REVIEW BY FORT BEND COUNTY COMMISSIONERS COURT

Job Location 3329 Lake Olympia Pkwy, Missouri City, TX 77459

Date 7/28/2016 Bond No. CHI-001686693-01, Permit No. 2016-8676 to make use of certain Fort Bend County property subject to, "A Revised Order Regulating the Laying, Construction, Maintenance, and Repair of Buried Cables, Conduits, and Pole Lines, In, Under, Across or Along Roads, Streets, Highways, and Drainage Ditches in Fort Bend County, Texas, Under the Jurisdiction of the Commissioners Court of Fort Bend County, Texas," as passed by the Commissioners Court of Fort Bend County, Texas the 3rd day of August, 1987, recorded in Volume _____ of the Minutes of the Commissioners Court of Fort Bend County, Texas, to the extent that such order is not inconsistent with Article 1436a, Vernon's Texas Civil Statutes. Upon Motion of Commissioner Meyers, seconded by Commissioner Patterson, duly put and carried, it is ORDERED, ADJUDGED AND DECREED that said notice of said above purpose is hereby acknowledged by the Commissioners Court of Fort Bend County, Texas, and that said notice be placed on record according to the regulation order thereof.

From: Gary Gehbauer <ggehbauer@browngay.co

RW012-W87438-ROUTE3;		NO SCALE A00A4W 281-437	
Byers Engineer			
	DRAWN BY:	JCS	
	DATE:	July 15, 2015	
	KEY MAP:	610H	
	PLAT:	1 of 1	
DWG NAME:		Vicksburg Blvd

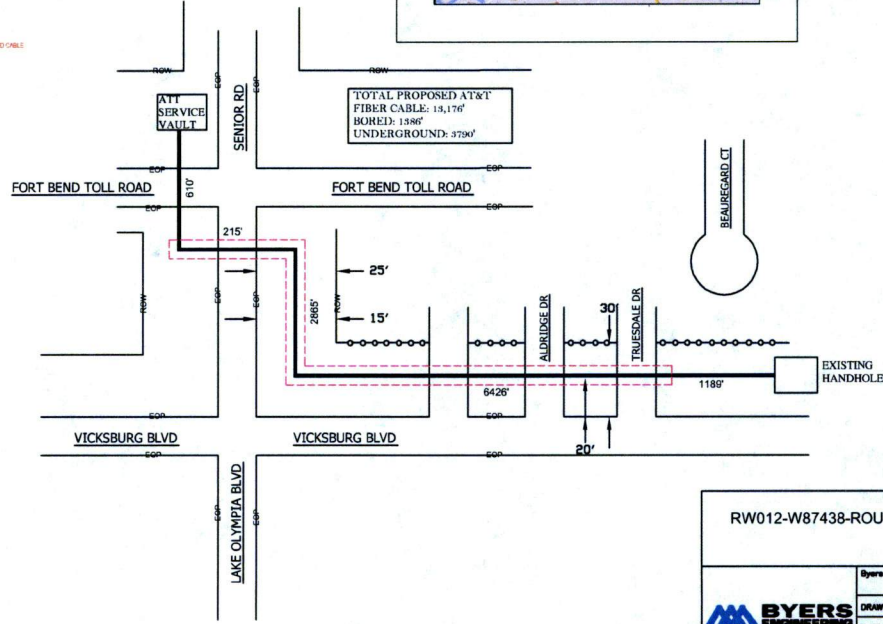
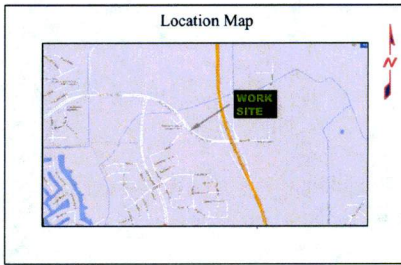
The engineering group from Byer /AT&T finally contacted us this morning. We have no objection to this work as long as the following notes are placed on the plans:

Utility Permit Notes for work within FBGPTRA and FBCTRA (collectively as FBTRA) Right of Way

- * All work must meet TxDOT / State of Texas utility accommodation requirements
- * Notify Phil Martin with FBTRA at least 48 hours prior to commencing work at (713) 574-5261: philmartin@mikestoneassociates.com

- * Utility owner must provide owner's responsible person's name and contact information (not contractor's contact information).
- * Any work within the toll road right of way requires a traffic control plan; even if lanes are not affected. TCP must meet TxDOT or TMUTCD requirements and be reviewed by FBTRA with no objections prior to starting work.

- * Access to SH 99 or Fort Bend Parkway must be coordinated with Phil Martin prior to work.
- * Bore pits within the right of way must be protected during non-work hours.

- * Contractor must clean roadway of dirt and debris prior at the end of each work day or prior to opening roadway to traffic
- * Peak hours are from 5am to 9am, and 3pm to 7pm. No lane closures permitted during peak hours without authorization from FBTRA.

- * Work areas that have been disturbed must be returned to the original condition and may be required to place grass sod and continual watering.
- * Upon completion of work, submit CADD/Microstation files and pdf of Record Drawings to Phil Martin with FBTRA.
